**Board of County Commissioners**  
**Okeechobee County**

**ADDENDUM NO. 1**

Project Name: **Okeechobee County Project No. 2017-04**  
**Warming Kitchen Addition for C. Scott Driver Pavilion**

Date: **March 24, 2017**

PARTIAL A-4

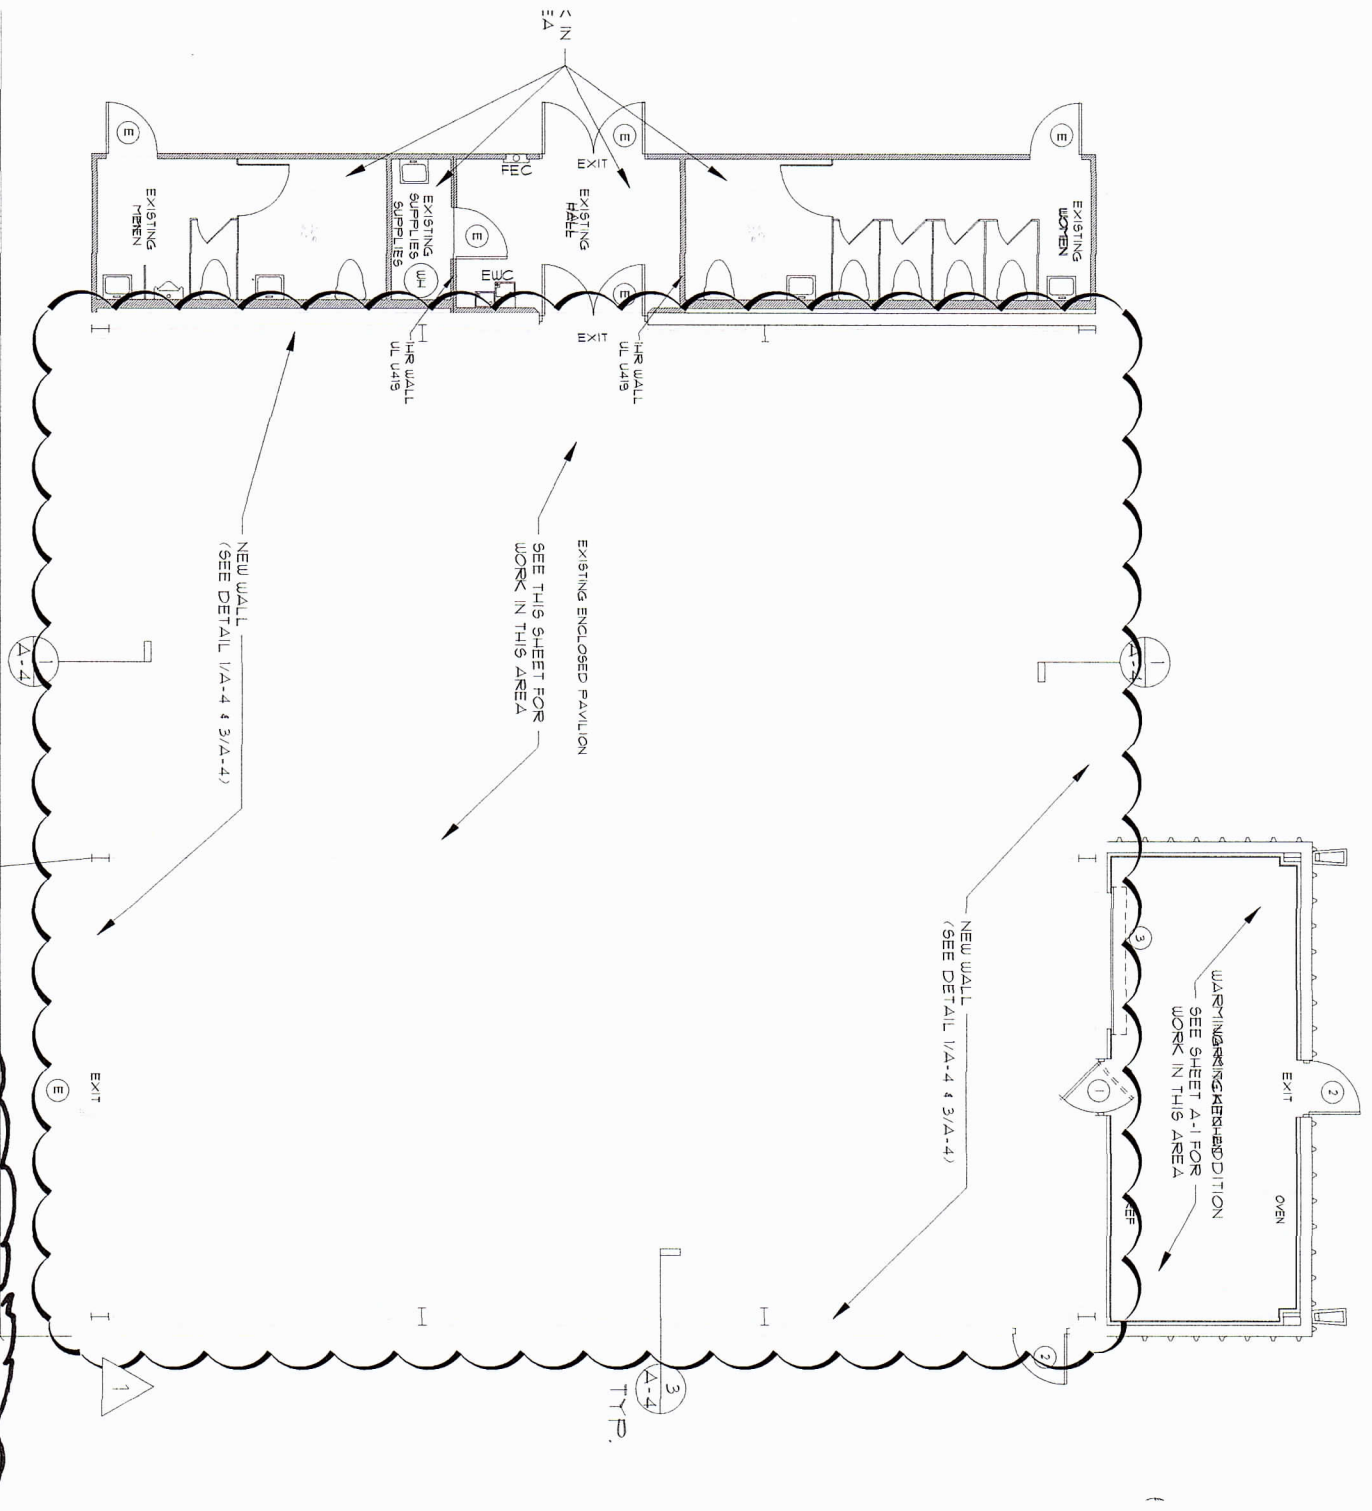
1. Clarify where new wall is going around enclosed pavilion on all 4 sides?  
**FIND ATTACHED REVISED PARTIAL SHEET A-4 ATTACHED**
2. Need side dimensions for the metal building addition?  
**FIND ATTACHED REVISED PARTIAL SHEET A-1 ATTACHED**
